City of Lakewood  
Board of Building Standards •  
Architectural Board of Review •  
Sign Review Board

MINUTES  
BOARD OF BUILDING STANDARDS/  
ARCHITECTURAL BOARD OF REVIEW/SIGN REVIEW  
REVIEW MEETING  
CITY OF LAKEWOOD  
12650 DETROIT AVENUE  
AUDITORIUM  
DECEMBER 11, 2025  
5:30 P.M.  
MEETING RECORDED

# Architectural Board of Review

January 2026

SHEET NO.  
8 of 10

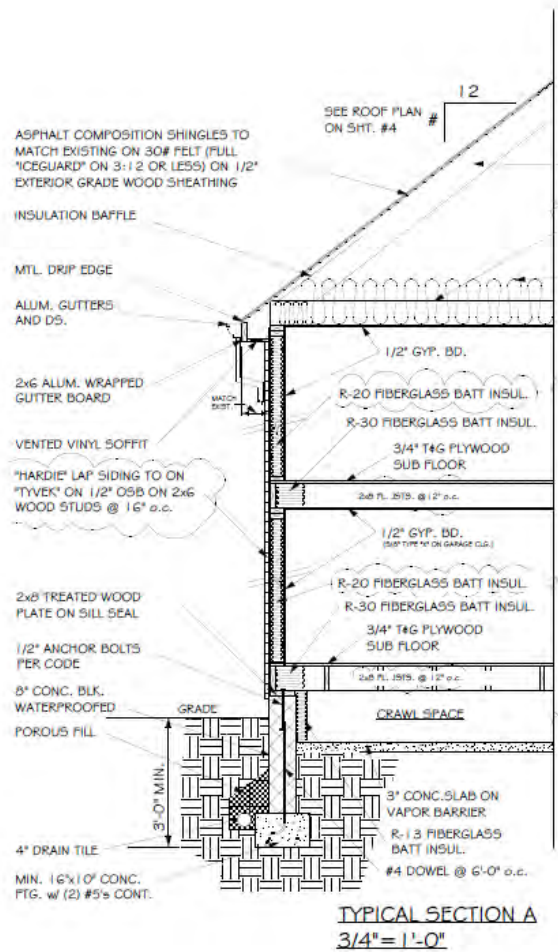
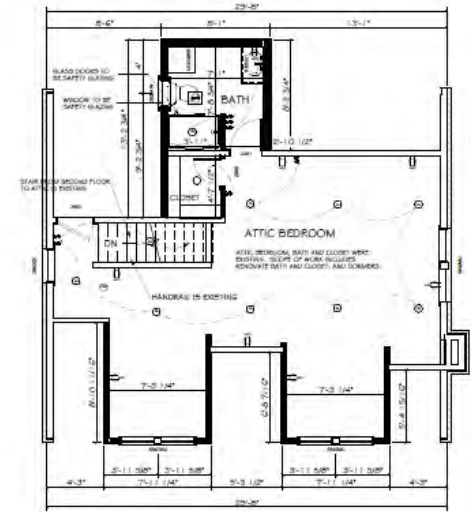
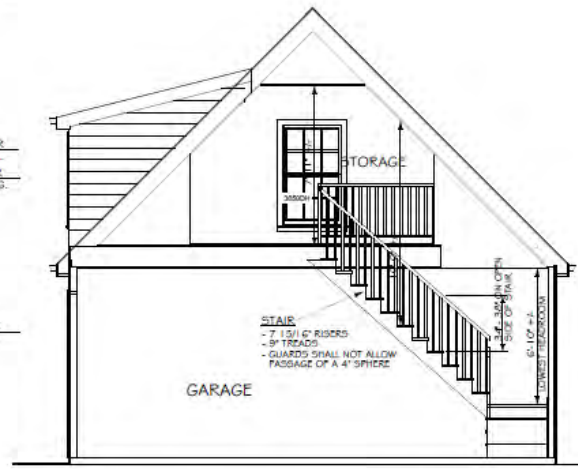
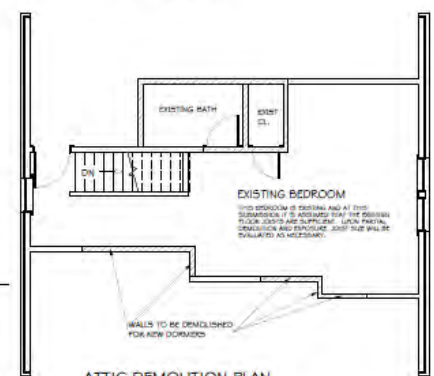
1. Item 1, Work contrary to approved plans. (RCO 108.6 & 108.6.1)

***a) Exterior wall cut on page 8 of the approved plans show exterior walls framing 2"x6". On site inspections, exterior walls are 2"x4". Revise plans to show this framing change.***

2. Item 2, Work contrary to approved plans. (RCO 108.6 & 108.6.1)

***a) Exterior wall cut on page 8 of the approved plans show R20 fiberglass batt insulation. On site inspection, exterior wall insulation is R15. Provide the minimal required insulation in the exterior wall as in the approved plans or provide an alternative to achieve the minimal R20. (RCO 1102.1.2)***
